**Planning & Zoning Commission
Tuesday, December 19, 2023, 6:00 PM
Public Meeting Room / Eagle Town Hall
200 Broadway, Eagle, CO 81631**

1. Project: Stone Concepts Minor Development Permit
File # DR23-01
Applicant: Teague Carlson
Location 85 Marmot Lane
Staff Contact: Tez Hawkins, Senior Planner
Request: A Minor Development Permit to construct a new warehouse on the currently vacant lot at 85 Marmot Lane.

Subject: DR23-01, Referral Responses, Stone Concepts Minor Development Permit Application
[10/13/23: Revised w/ Applicant Responses], [10/31/2023: Revised for clarification with Public Works]

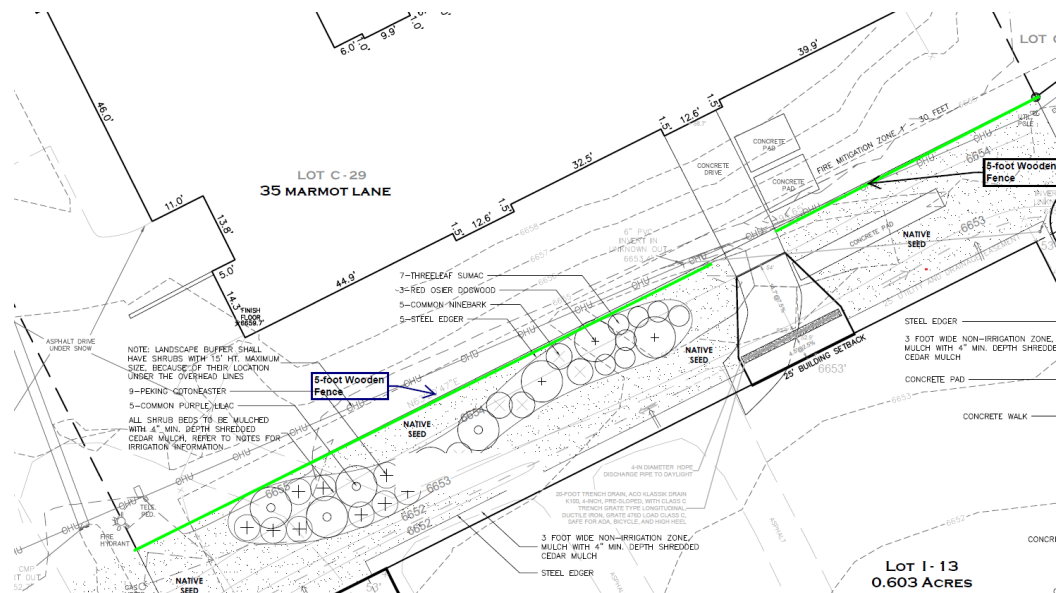
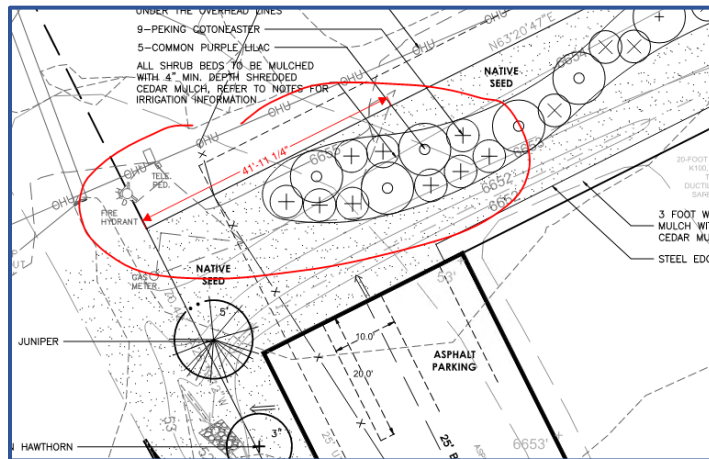
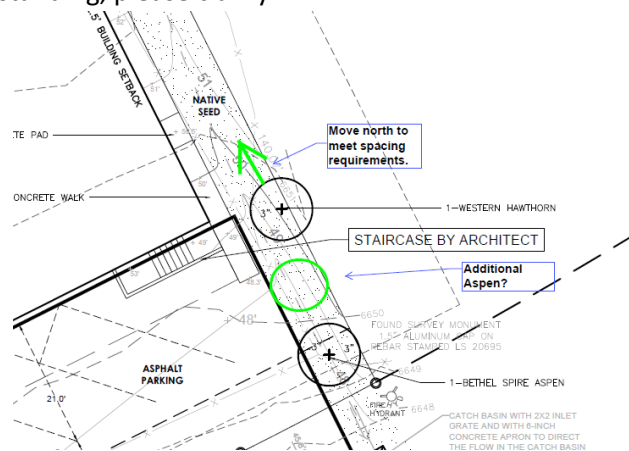
The planting strip will need to be moved inside the property line or the a landscape design variance must be requested and granted by the planning commission; an Town right-of-way encroachment permit is also needed if the design variance is pursued. However, staff recommends that the landscape buffer is accomadated with the Property boundaries based on historic approvals.

4. Per [Section 4.07.020.B](#), The boundaries of every development shall be landscaped to adequately buffer potential incompatibility between adjacent land uses. Screening of parking lots from adjacent properties shall be required. Screening must be provided to eliminate headlight glare from the lot onto the adjacent property and to screen views into parking lots. Planting buffers along the edge(s) of parking lots must be a minimum of five feet wide, or a combination of fencing and a two-foot-wide buffer may be used. Additionally, [Section 4.07.070.C.6](#) requires industrial lots that abut commercial lots to provide a landscaped and fenced buffer.

The property to the north is zoned commercial, and the proposed development's parking stalls have the potential to create glare into the northern commercial property. Please provide an adequate fencing buffer. A 4-5-foot wooden fence along the Property line should suffice and avoid overhead powerline height restrictions and additional building permits. The concrete drive does not need to be fenced, but a fence needs to be placed on both sides of the concrete drive. Please refer to the image below. It's understood that Stone Concepts operates on both properties; however, both properties and uses must be treated separately.

SC: This question is asking to add a fence between the 1210 Chambers and 85 Marmot Lane properties. Although we use the two properties in a concurrent nature, we understand that they will need to be treated as separate entities. We will add a split rail fence at the green line indicated in the referral similar to the below image. This fence is similar to what has been installed between Slifer Designs and The Thrifty Shop (who are our closest neighbors).

Town: Please submit revised plans showing the fence to address this comment. Additionally, the first 40 feet of the fence, starting from the southwest property corner, should be closedboard fencing to prevent glare onto the adjacent property; the remaining fence can be split-rail wood fencing.
